Technical Review Committee Agenda

**CITY OF DELAND
THURSDAY APRIL 18, 2024 AT 1:30 P.M.
CITY OF DELAND TRC MEETING ROOM
DELAND, FLORIDA**

**CITY OF DELAND
TECHNICAL REVIEW COMMITTEE MEETING
MEETING MINUTES
THURSDAY, MARCH 21, 2024 - 1:30 P.M.
CITY HALL**

City of DeLand
SP24-008
DELAND FSER

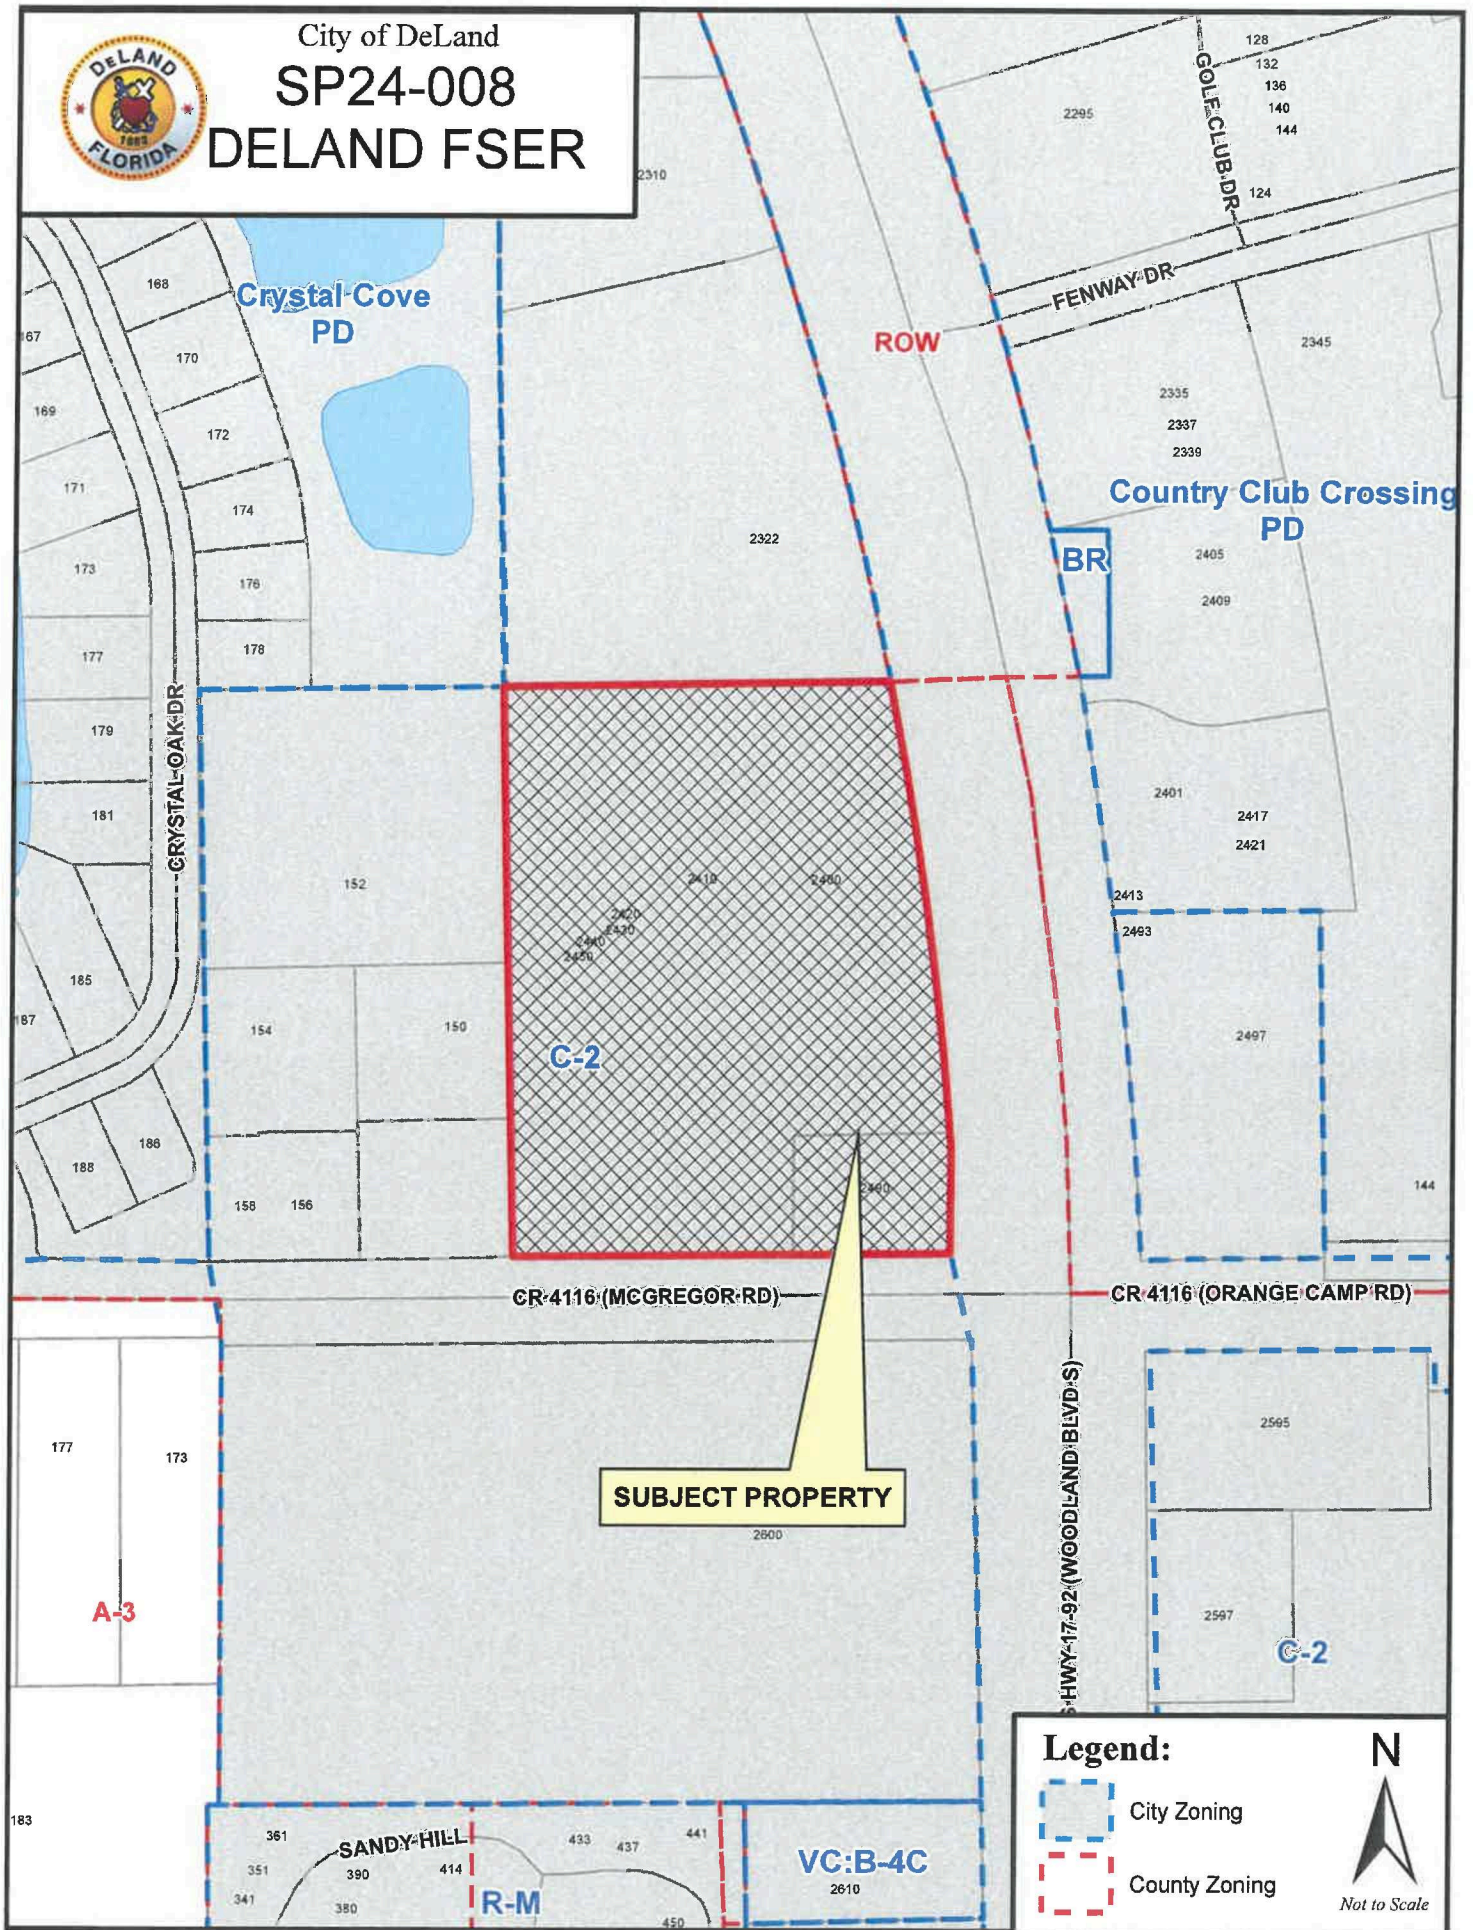
Discipline	Status	Details	Attached To	Created By	Last Updated By	Modifications Required
Forestry	Draft	Historic Tree Barricade Detail There is at least one historic tree on the site. The City's Historic Tree Barricade Detail will need to be added to the plan. The detail can be found on our website. This detail is in addition to the Typical City Tree Barricade Detail.	C3.1	Kit Dennis	Kit Dennis	Yes
Forestry	Draft	Historic Live Oak There is at least one historic tree shown on your plan. The one I can identify is shown as a 42" Live Oak located at the SE corner of the site. This tree (and any other historic trees on the site) will need to be protected with a historic tree barricade. The historic tree barricade detail can be found on our website and will need to be added to the plans. The locations of the historic tree barricades will need to be identified on the plans as well.	C3.0	Kit Dennis	Kit Dennis	Yes

Forestry	Draft	Note 1 Palme trees are included in the calculations and this note should be removed. Including the palm, your plan provides 188" DBH replacement (196" if the Japanese Blueberry size is increased). Without the palms or Blueberry trees your plan only provides 124" DBH and may not meet the minimum coverage requirements. I cannot determine that until a spreadsheet has been received.	L0.0	Kit Dennis	Kit Dennis	Yes
Forestry	Draft	Tree Mitigation Calculation Table The proposed tree inches in your plant schedule is 188" including the palms. If you increase the size of the Japanese Blueberry trees to 3" caliper your plant schedule would provide 196" DBH. The number of proposed inches shown in the table should be changed to reflect what's provided in your plant schedule. The same table on the other sheets throughout the plan should match the table shown here.	L0.0	Kit Dennis	Kit Dennis	Yes

Forestry	Draft	Japanese Blueberry The Japanese Blueberry trees are still being shown as 2" caliper. These trees would not be counted towards minimum coverage requirements.	L1.1	Kit Dennis	Kit Dennis	No
Forestry	Not Accepted	Tree Protection Areas At 297,079 sqft, the site requires 44,562 sqft of Tree Protection Area. Show the TPA in the plans with the dimensions of the area. Last comment from reviewer: Concrete areas such as sidewalks need to be removed from the TPA calculations. The area needed for retention area maintenance should also be removed. These areas should not be shown as TPA.		Kit Dennis	Kit Dennis	Yes

Discipline	Status	Details	Attached To	Created By	Last Updated By	Modifications Required
Last response: See attached comment response letter and updated associated sheet(s).						
Tree Survey						
A tree survey for the entire site is needed. The survey should list trees by species and show their DBH. Indicate which trees are to be retained and which will be removed. I cannot determine if the site will meet minimum coverage requirements until the survey has been received.						
Forestry	Not Accepted	Last comment from reviewer: The trees are hard to pick out on the plan sheets. Please provide a spreadsheet that identifies all trees within the project boundary with a DBH of 6" or larger. Include the tree species, DBH, and show which trees will be removed and which will be retained. This information is needed to determine if the site will meet minimum coverage requirements.		Kit Dennis	Kit Dennis	Yes

Last response: See attached comment response letter and updated associated sheet(s).						
Minimum Coverage Requirements (Informational)						
The site is shown as 297,079 sqft. The minimum coverage requirements would be 119 trees. 714" DBH, 44,562 sqft of Tree Protection Area.						
Forestry	Not Accepted	Last comment from reviewer: At 66,780 sqft the site will require 27 trees and 160" DBH to meet the minimum coverage requirements. I cannot determine if the site will meet minimum coverage until a spreadsheet of the existing trees has been received and the specs in the Plant Schedule have been corrected to meet Grade 1 standards.		Kit Dennis	Kit Dennis	Yes
Last response: See attached comment response letter and updated associated sheet(s).						
Planning	Draft	Issue Response Please respond to each issue individually in the Accela Citizen Portal for each review cycle as opposed to a response letter.		Samuel Nelson	Samuel Nelson	Yes

Planning	Draft	Uses Permitted for Existing Building Only uses with a low-parking requirement will be permitted within the existing building to prevent creating a nonconforming parking situation.		Samuel Nelson	Samuel Nelson	Yes
Planning	Not Accepted	Traffic Impact Please remove the trip generation table from the cover and provide a signed and sealed traffic impact memo from an engineer. The memo will need to reflect the current uses, which do not include a supermarket, as well as all anticipated future retail or commercial uses for the existing structure.	C0.0	Phillip Mangis	Samuel Nelson	Yes
Last comment from reviewer: A traffic impact memo was not located within this submittal, please provide the memo in the resubmittal.

Please provide a photometric plan, per Section 33-94.02(c)(2) showing all exterior lighting schemes and designs, of the entire site. No more than 0.5-foot candles are permitted at the property line.

Building mass shall be varied by height and width so it appears to be divided into distinct massing elements and architectural details can be viewed from a pedestrian view point. Please verify that the proposed architecture meets the community design standards.

For each of the elevations, please provide the dimensions and indicate how the building complies with the uninterrupted facade requirements. For structures with 75 or less linear feet of building ground floor frontage, fronting on or visible from the public right-of-way, no uninterrupted horizontal length or uninterrupted curve of the building facade shall exceed 35 linear feet, except for architectural facades, which may be allowed to have an uninterrupted length of 60 linear feet. For structures with greater than 75 but less than 200 linear feet of building ground floor frontage, fronting on or visible from the public right-of-way, no uninterrupted horizontal length or uninterrupted curve of the building facade shall exceed 100 linear feet, except for architectural facades, which may be allowed to have an uninterrupted length of 120 linear feet.

Please provide dimensions for each of the projections and recesses to demonstrate consistency with the Community Design Standards (Projections and recesses from uninterrupted facade lengths shall be architectural features and have a minimum depth of three feet. A minimum of 25 percent of the uninterrupted facade lengths shall be of varied length.)

Buildings shall have consistent window expression visible from the street. A punched window expression is encouraged. Windows (real or false) shall be placed along at least 30 percent of any facade length that is visible from a public right-of-way. Windows shall be recessed or shall project at least one-half inch and shall include prominent sills, shutters, cementitious material reliefs or other such forms of framing. The elevations do not appear to meet this standard. Please verify that this standard has been met and provide additional windows where needed.

Last comment from reviewer: Please provide the photometric information for the entire site, and please clearly label the property line on the plan.

The northern elevation, specifically the large section of blank wall, does not appear to meet the standards of 33-94.03 (b) of the Land Development Regulations. Please provide enhanced architectural features.

Discipline	Status	Details	Attached To	Created By	Last Updated By	Modifications Required
Last response: See attached comment response letter and updated associated sheet(s).						
Landscape Buffers Please label and dimension all landscape buffers and their widths to show how they were calculated.						
Planning	Not Accepted	Last comment from reviewer: This section of S Woodland Blvd is located within the redevelopment corridor, which requires a minimum 4" dbh please revise the table with this correction. Last response: See attached comment response letter and updated associated sheet(s).	L1.0	Phillip Mangis	Samuel Nelson	Yes
Parking Please indicate the number of parking spaces in specific areas.						
Last comment from reviewer: The proposed parking appears to be insufficient for the site upon construction of the FSER and consolidation of the properties. Existing Building Area: 57,668 SF Net Area: 57,668 x 0.85 = 49,017.8 Current Parking Requirement: 49,017.8 / Retail Requirement (1 space / 250 SF floor area) = 196 FSER Requirement upon approval of Proposed LDR amendment: (1 space per 1 staff on maximum shift) (12 spaces for 12 proposed staff) + (1 space per 2 exam rooms or beds) (11 exam rooms = 5.5 spaces, rounded to 6) 12 + 6 = 18 spaces required for FSER subject to LDR update. 196 Spaces Required for existing building + 18 Spaces required for FSER subject to LDR update = 214 Total Spaces Required. Required Spaces of 214 less the Provided Spaces of 198 gives a deficit of 16 parking spaces. A portion of the parking requirement may be offset with the addition of bicycle parking subject to the requirements of the code. Please revise the plan to show how the required parking will be met.

Planning	Not Accepted		C5.0	Phillip Mangis	Samuel Nelson	Yes
Last response: See attached comment response letter and updated associated sheet(s).						
Property Lines It is unclear where the property lines are located. Please show all property lines as solid, bold lines throughout the construction plans. The dimensions of all features on the site must be indicated such as building dimensions, building setbacks measured from the						
Planning	Not Accepted		C5.0	Phillip Mangis	Samuel Nelson	Yes

Discipline	Status	Details	Attached To	Created By	Last Updated By	Modifications Required
		property line, all driveway widths, sidewalk and street widths. All proposed improvements must be tied to the property lines.				
		Last comment from reviewer: Please show the property lines only for the property upon completion of the lot consolidation. Please remove the existing interior lines shown.				
		Last response: See attached comment response letter and updated associated sheet(s).				
		Tree Protection Area Fifteen percent (15%) of the square footage of any new development shall be designated for the protection of trees. Please clearly indicate the location of the tree protection areas on the site plan and provide a calculation of the area.				
Planning	Not Accepted	Last comment from reviewer: Please provide dimensions for the proposed tree protection area on the plan.	C4.0	Phillip Mangis	Samuel Nelson	Yes
